**County of Santa Clara**  
**Department of Planning and Development**  
County Government Center, East Wing, 7th Floor  
70 West Hedding Street  
San Jose, CA 95110  
Phone: (408) 299-5700  
www.sccplandev.org

**STAFF REPORT**  
**Zoning Administration**  
**March 2, 2023**  
**Item #2**

**PLN22-010**  
**Design Review Tier II and Grading Approval**

Summary: Design Review Tier II and Grading Approval for a one (1) story 6,298 square foot single-family residence with a 1,160 square foot attached garage and a 1,174 square foot detached accessory dwelling unit (ADU), a 960 square foot swimming pool and associated firetruck turnaround. Proposed estimated grading quantities are 505 cubic yards of cut and 460 cubic yards of fill with a maximum depth of 3.5 feet.

**GRADING AND DRAINAGE PLAN**

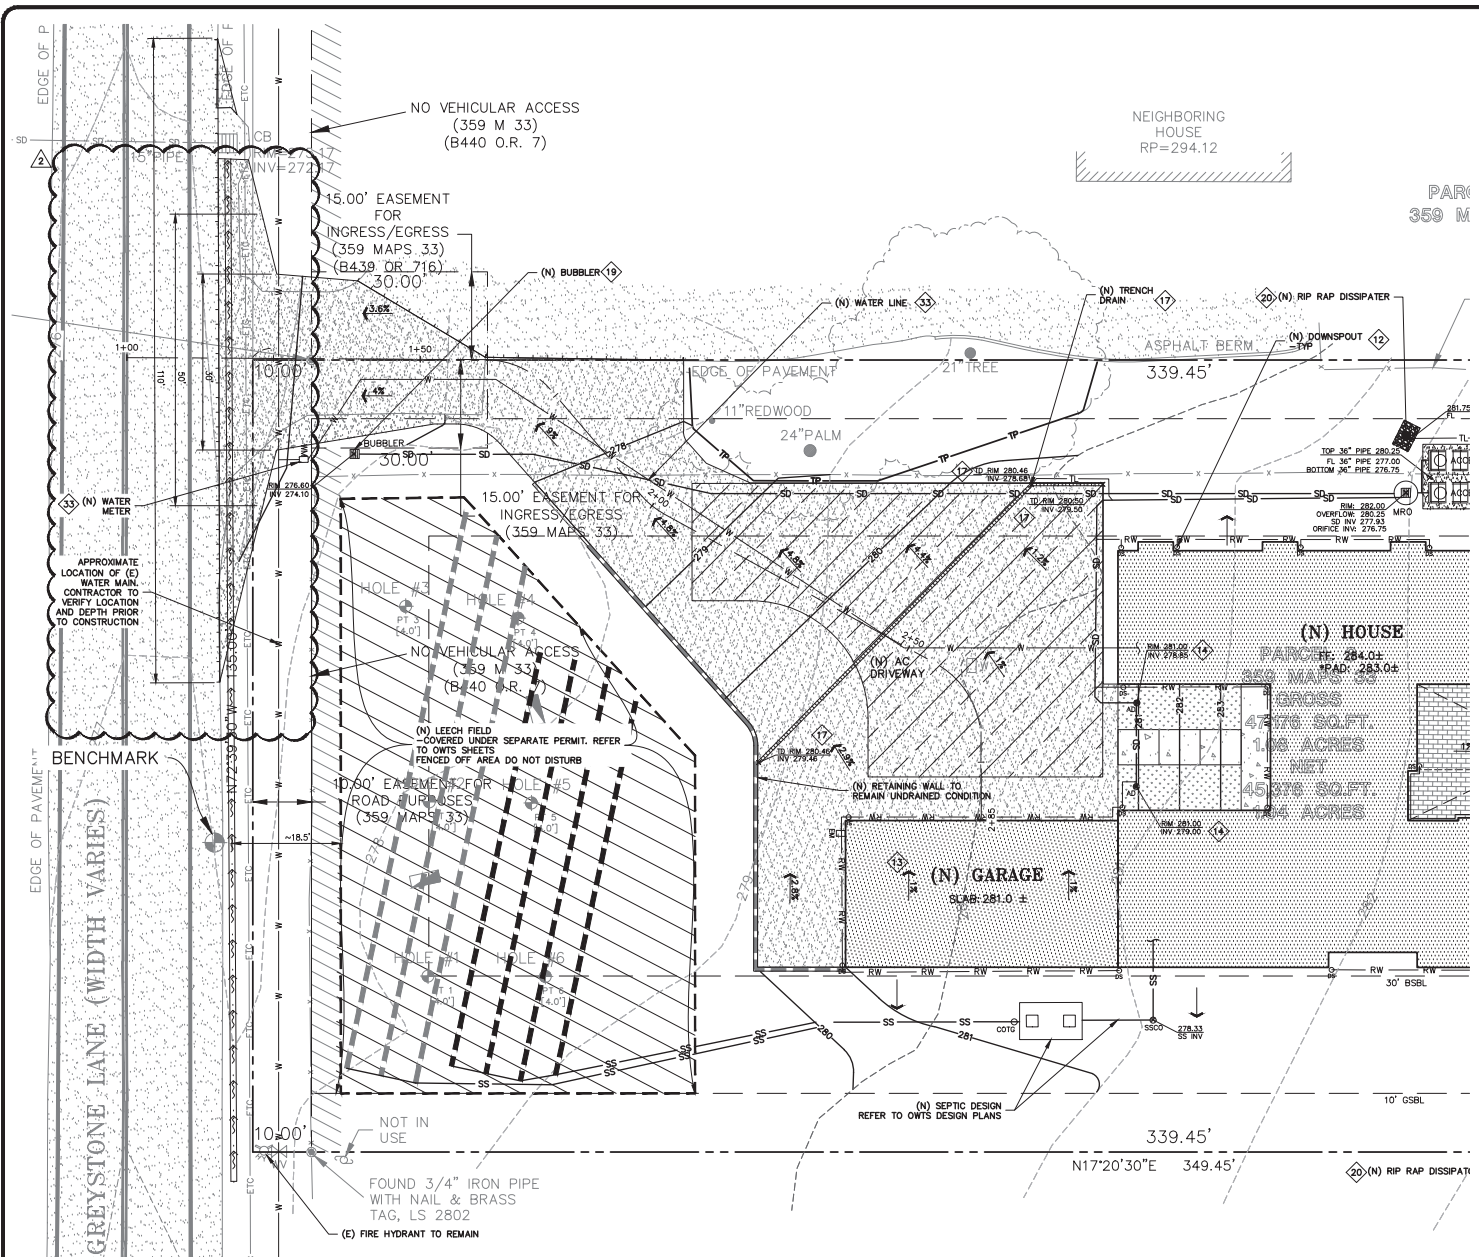
51. On plans to be submitted for a Grading Permit, the following revisions must be addressed:

- a) References to the “Santa Clara Valley Water District in Keynote #33 on Sheets C-3.0 and C-3.1 need to be removed and replaced with the water retailer for the parcel.
- b) References to “earthen swale” in Keynote #9 on Sheets C-2.0 and C-2.1 should be corrected to note “AC swale.”
- c) Keynote #20 on Sheets C-3.01 and C-3.1 should reference Detail #8 on Sheet C-4.0 and not Sheet C-4.1.
